Donald L. Welch
Architect

February 24, 2017 (Revised 04-23-2017)

RE: Brighton Recovery Campus
Plan Review Comment Responses
Building 'D'
4925 South 900 East
Salt Lake County, Utah

CODE REVIEW COMMENT RESPONSES:

DEMOLITION PLAN

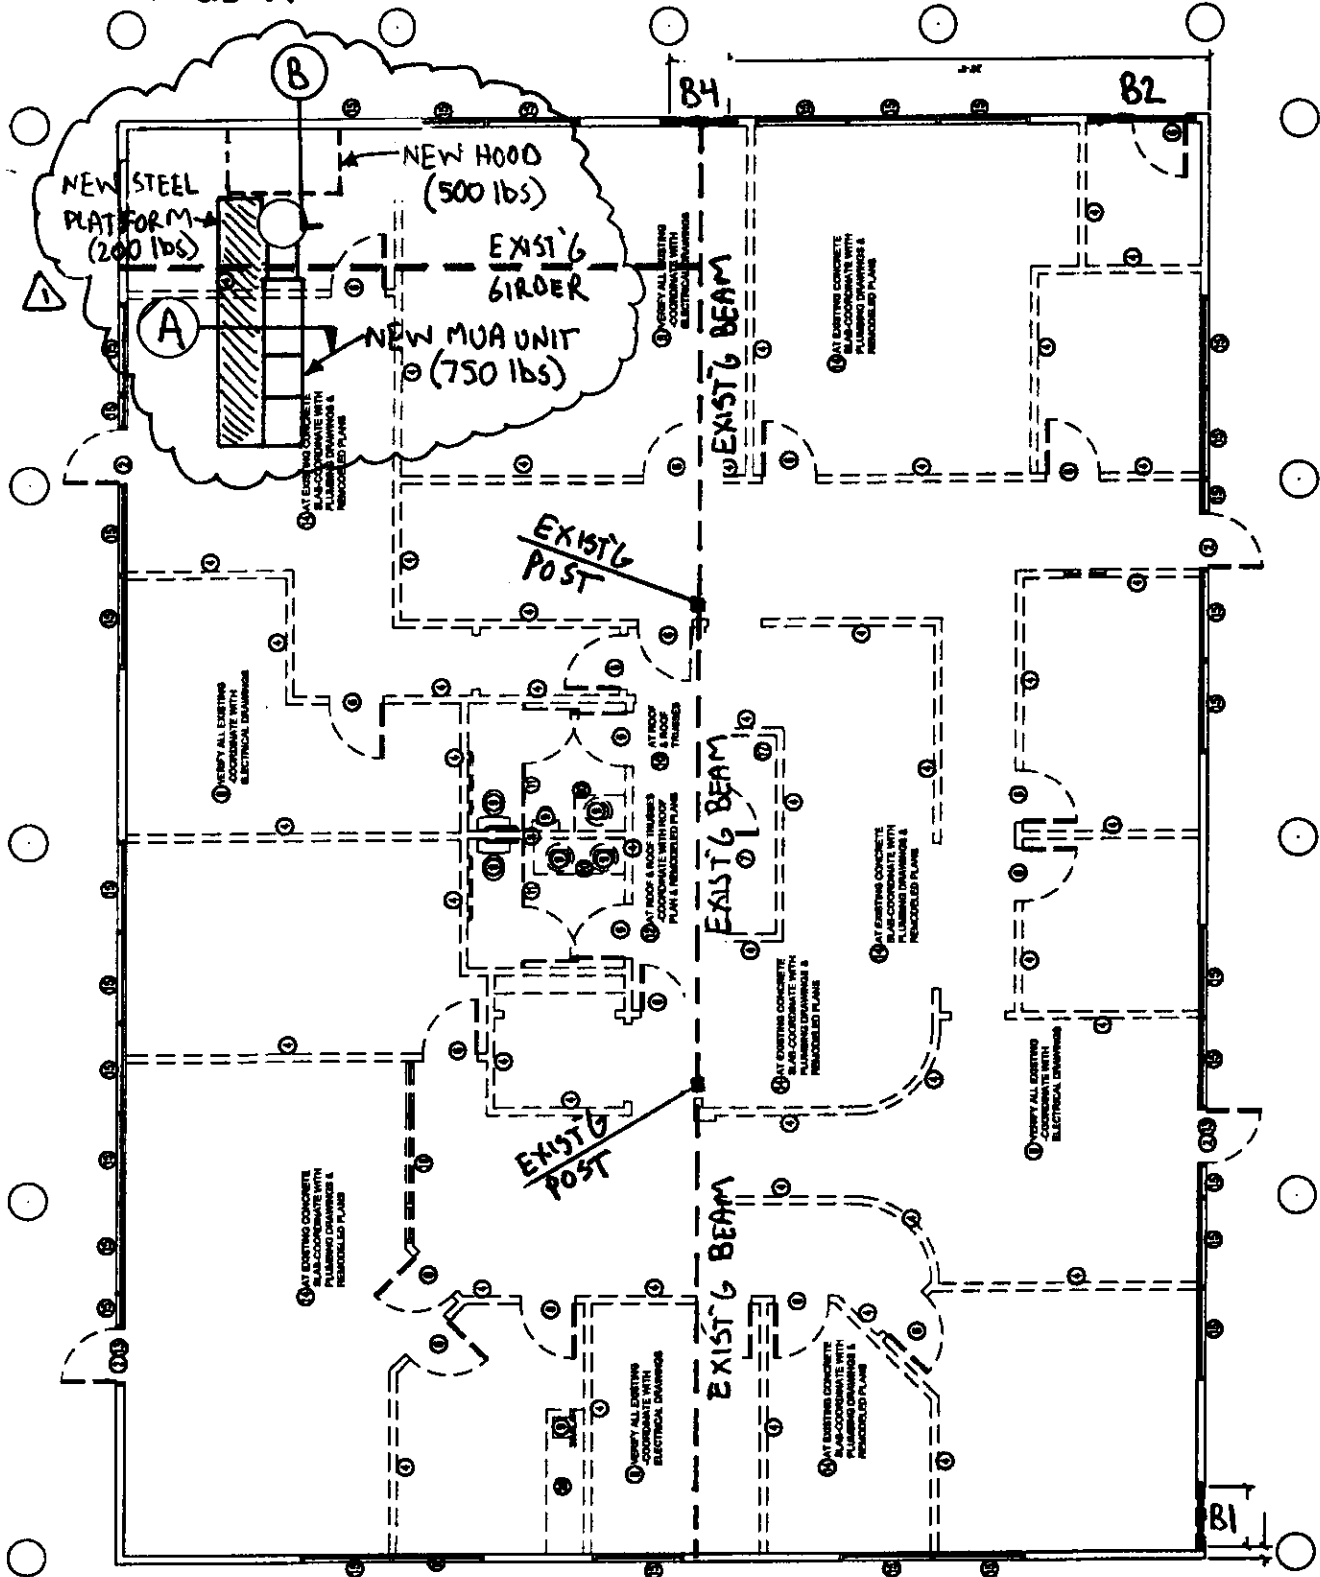
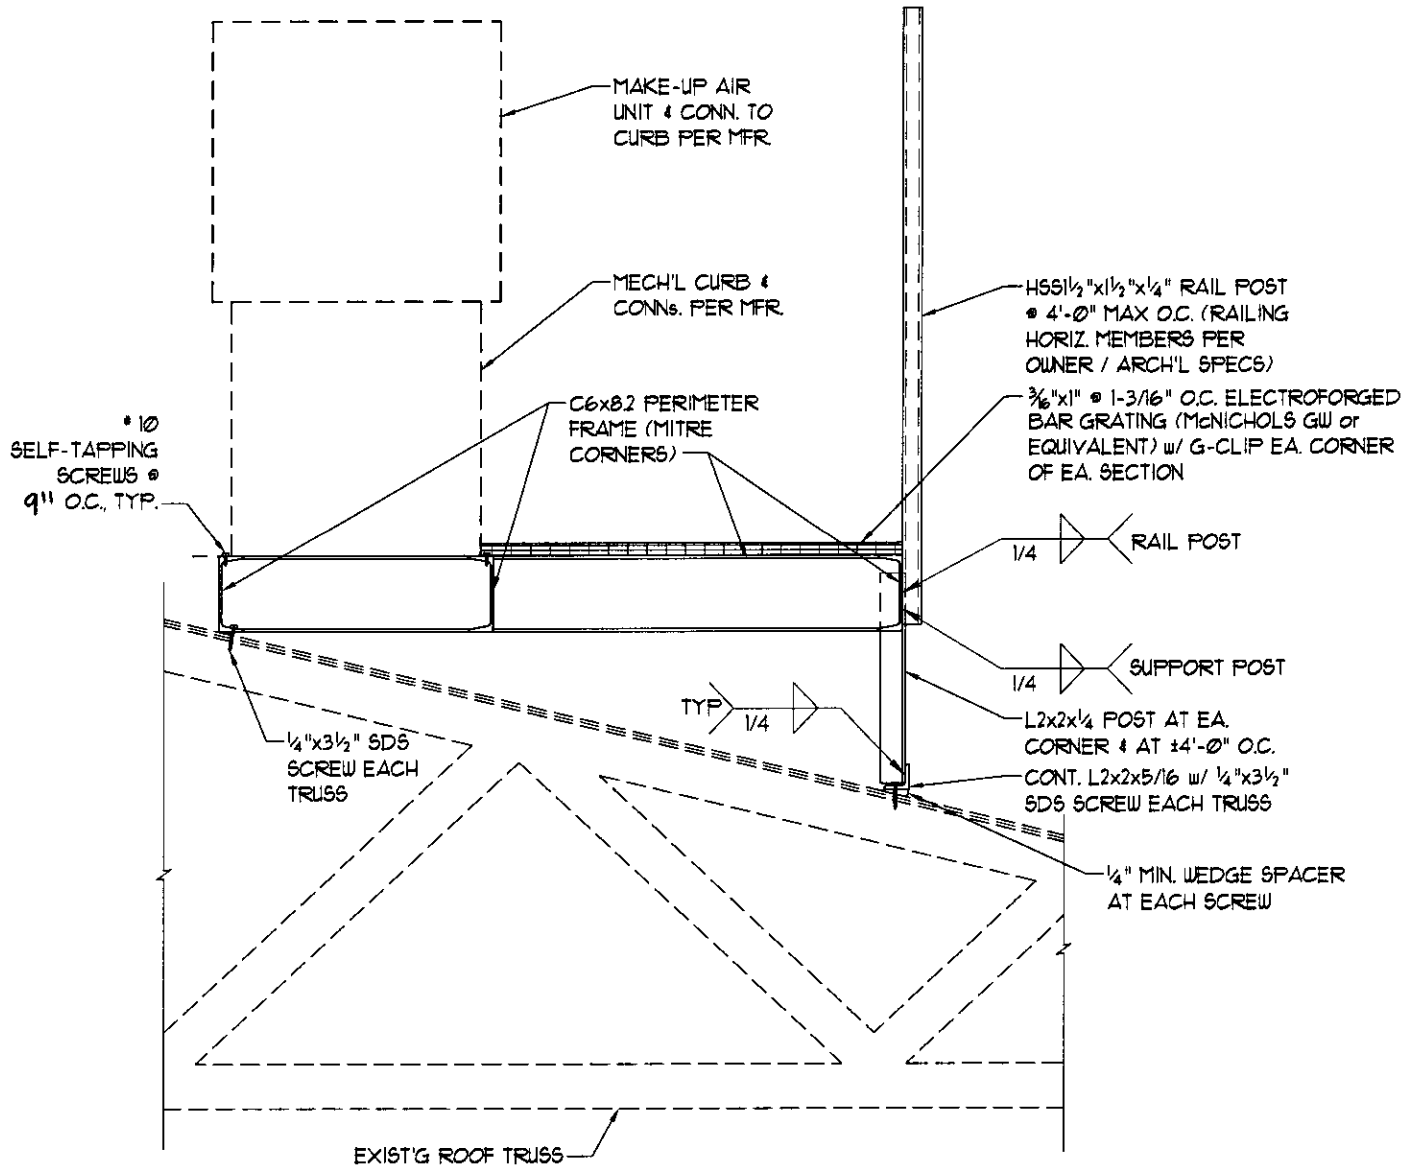
- 2) Three new openings may be constructed at exterior walls, as shown in the enclosed "Demolition Plan." The new headers, trimmers, and king studs are also specified on sheet 2. Supporting calculations are provided on sheets 5 and 6, enclosed. The contractor is responsible for shoring the existing roof framing during construction.

- 3) A new Make Up Air Unit and access platform may be placed on the existing roof, where indicated in the enclosed "Demolition Plan." See enclosed sheets 3 and 4 for details and sheets 7 and 8 for supporting calculations.

C-100

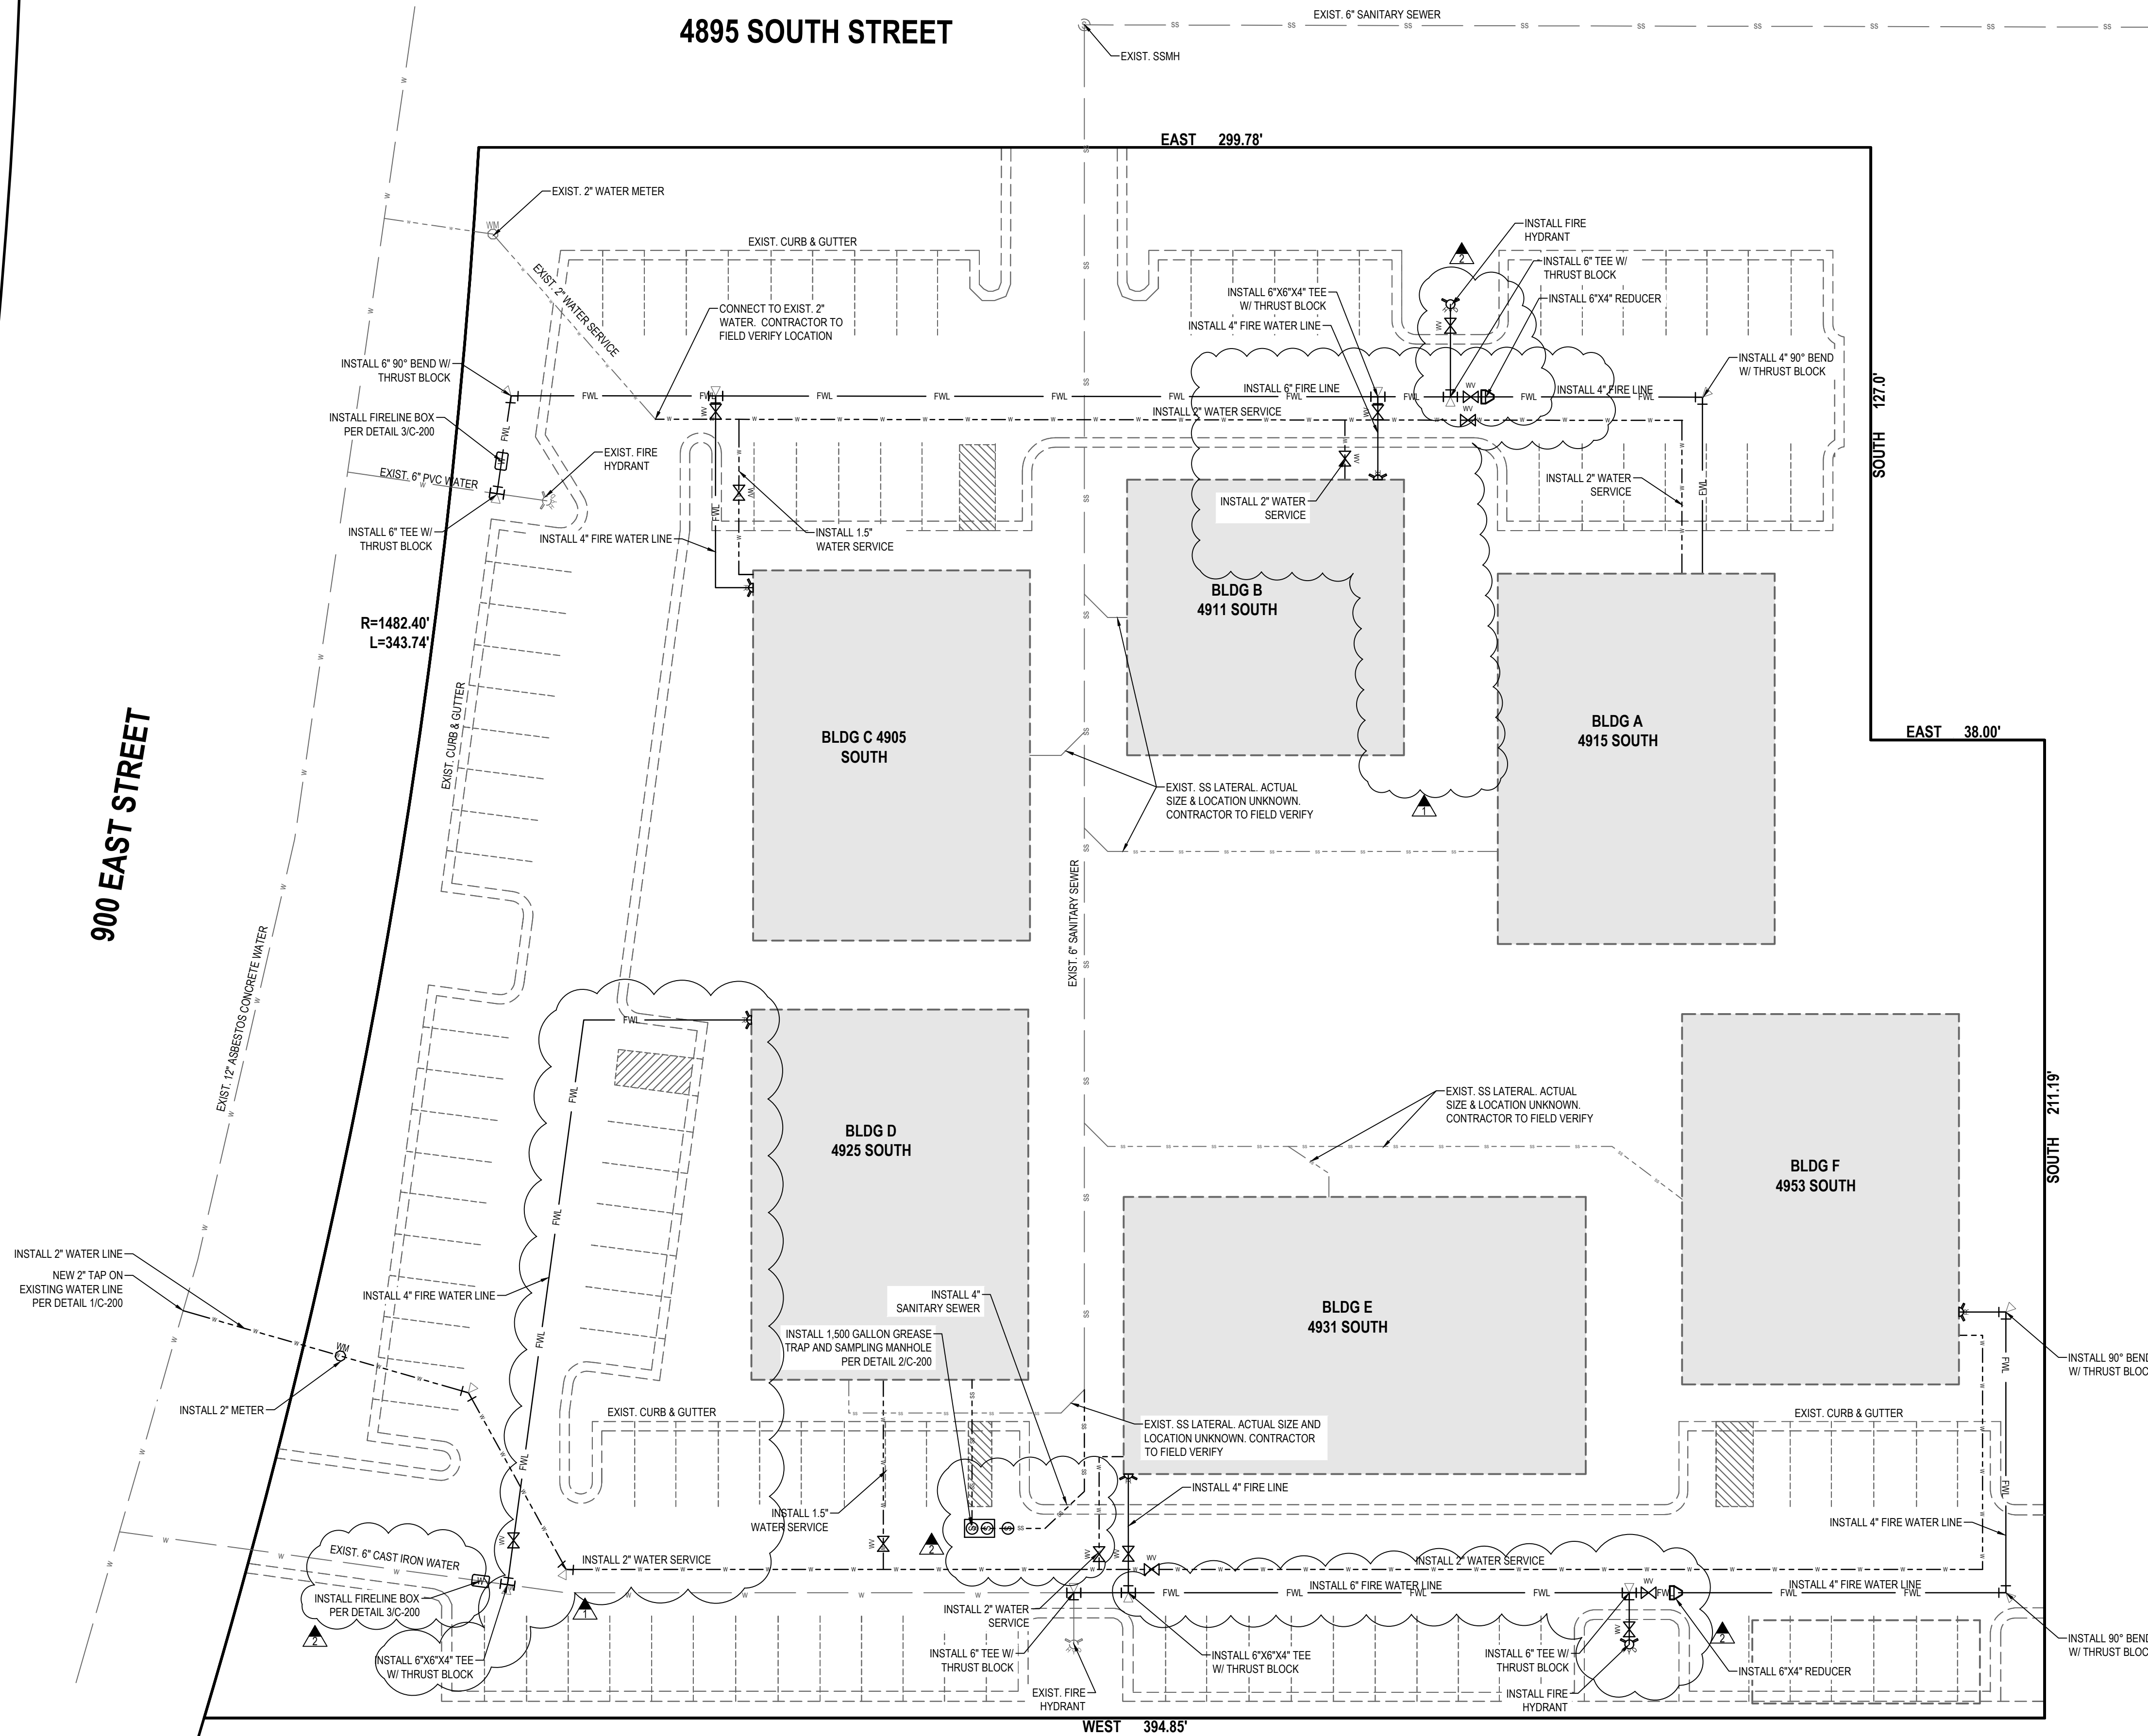
- V. Please refer to Sheet A1.1, and Sheet C100 for relocation of grease interceptor and sampling manhole away from accessible parking stalls.
 - VI. Please refer to Sheet A1.1, for new note concerning required slope at accessible parking stalls and aisles.
